MODIFICATION WORK ORDER

MWO 9-2320-280-20-1

MODIFICATION OF 1-1/4 TON VEHICLES

This modification provides a retrofit to the latest configuration of power steering systems on M998 Series vehicles fielded under contract DAAE07-83-C-R034.

FIGURE 1

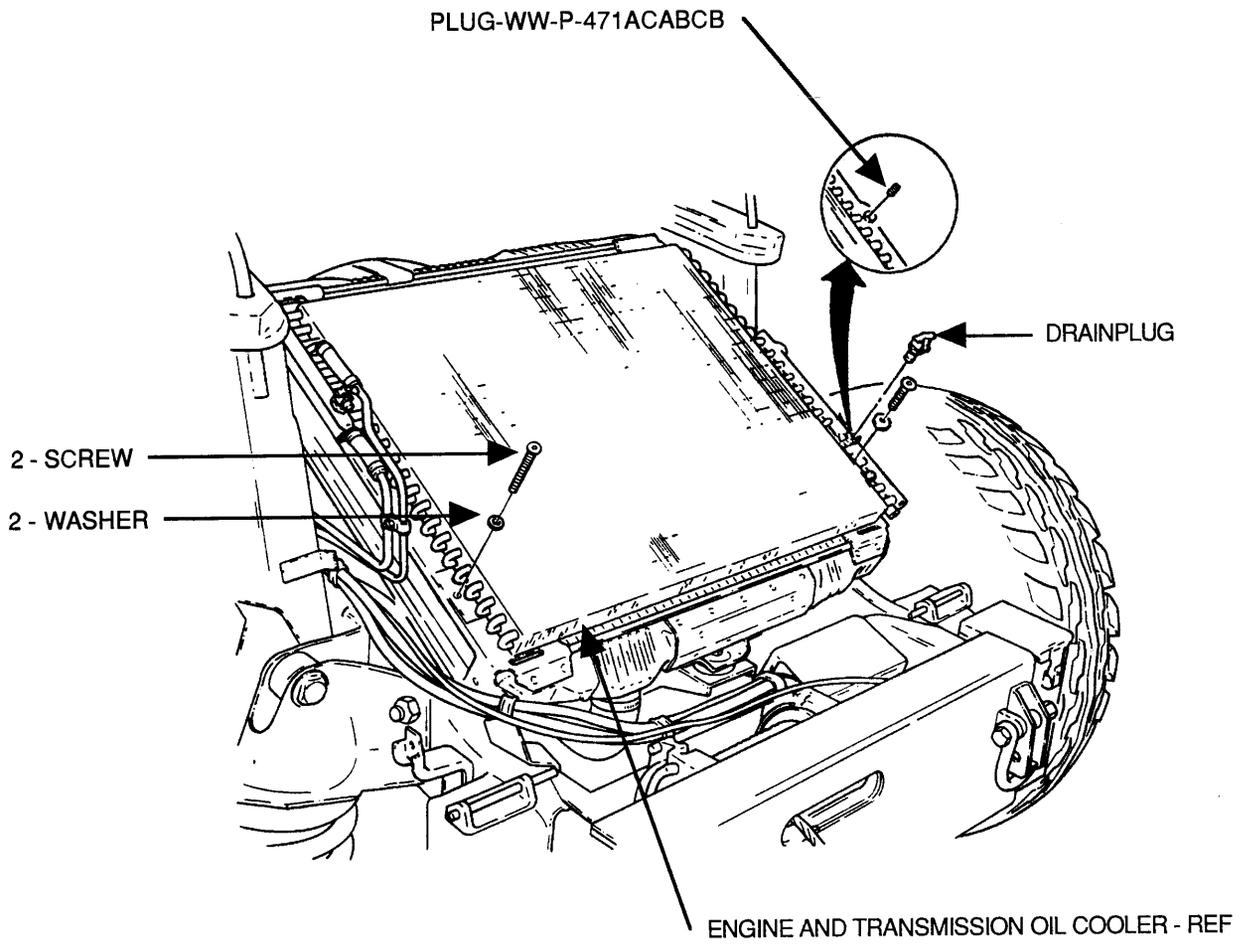
- (1) Disconnect battery ground cable. (Refer to TM 9-2320-280-20.)
- (2) Remove hood. (Refer to TM 9-2320-280-20.)
- (3) Remove left side splash shield. (Refer to TM 9-2320-280-20.)
- (4) Remove drainplug from oil cooler as shown in figure 1.

- (5) Install WW-P-471ACABCB plug in oil cooler as shown in figure 1.
- (6) Remove two lower screws and washers from oil cooler as shown in figure 1.
- (7) Remove two nuts, washers, screws, and clamps from power steering hoses as shown in figure 2. Save for installation.
- (8) Remove two clamps and hose from control valve elbow and steering gear as shown in figure 2. Save for installation.

FIGURE 3

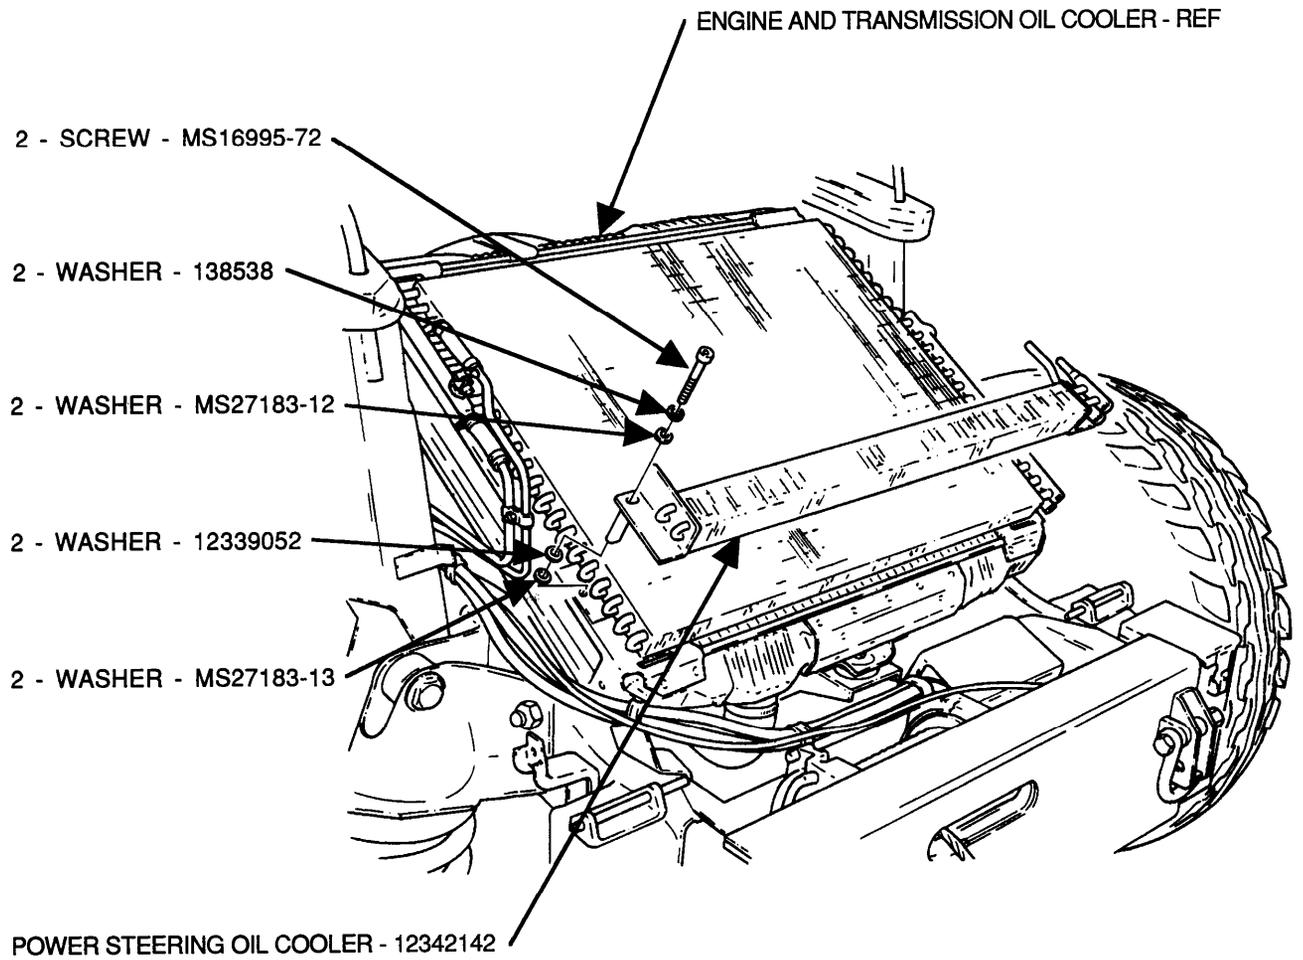
(1) Position two MS16995-72 screws, 138538 washers, and MS27183-12 washers to 12342142 power steering oil cooler as shown in figure 3.

(2) Position two 12339052 washers and MS27183-13 washers to oil cooler as shown in figure 3.

(3) Install power steering oil cooler to oil cooler and secure with two screws as shown in figure 3. Tighten screws to 12-14 lb-ft (14-18 N m).

FIGURE 4

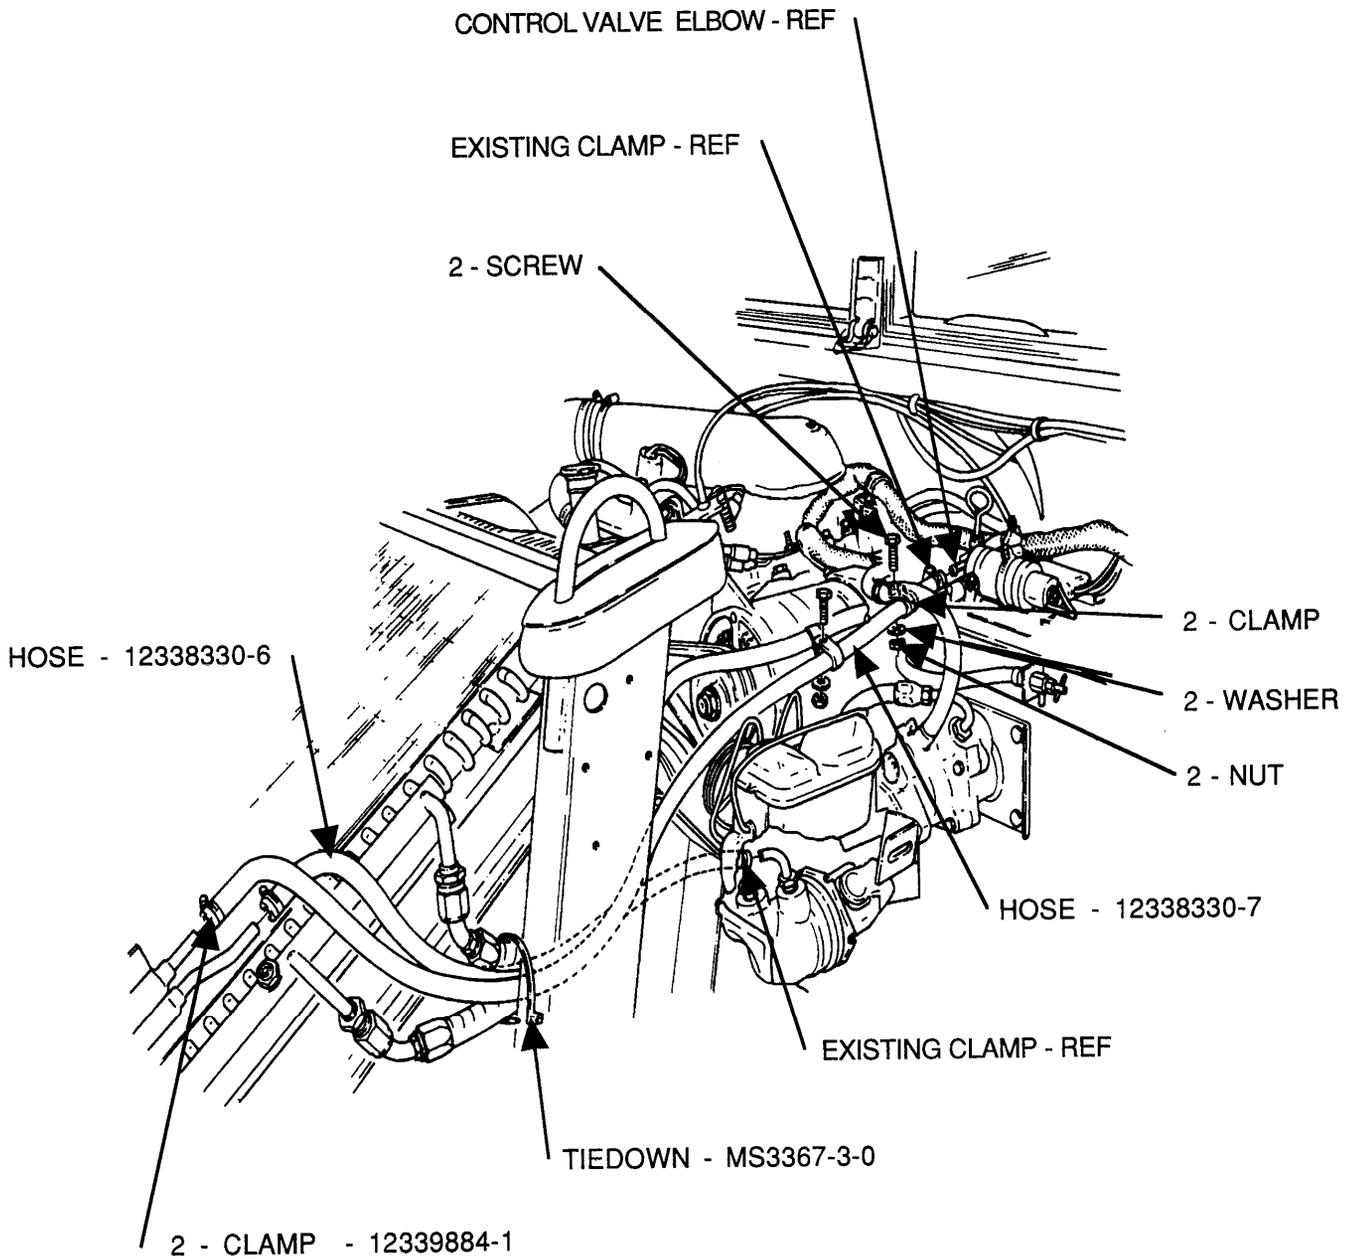
(4) Install 12338330-6 hose to power steering oil cooler and power steering gear and secure with 12339884-1 clamp and existing clamp as shown in figure 4.

(5) Install 12338330-7 hose to power steering oil cooler and control valve elbow and secure with 12339884-1 clamp and existing clamp as shown in figure 4.

(6) Position two existing clamps on hose and secure with two screws, washers, and nuts as shown in figure 4.

(7) Secure hoses with MS3367-3-0 tiedown as shown in figure 4.
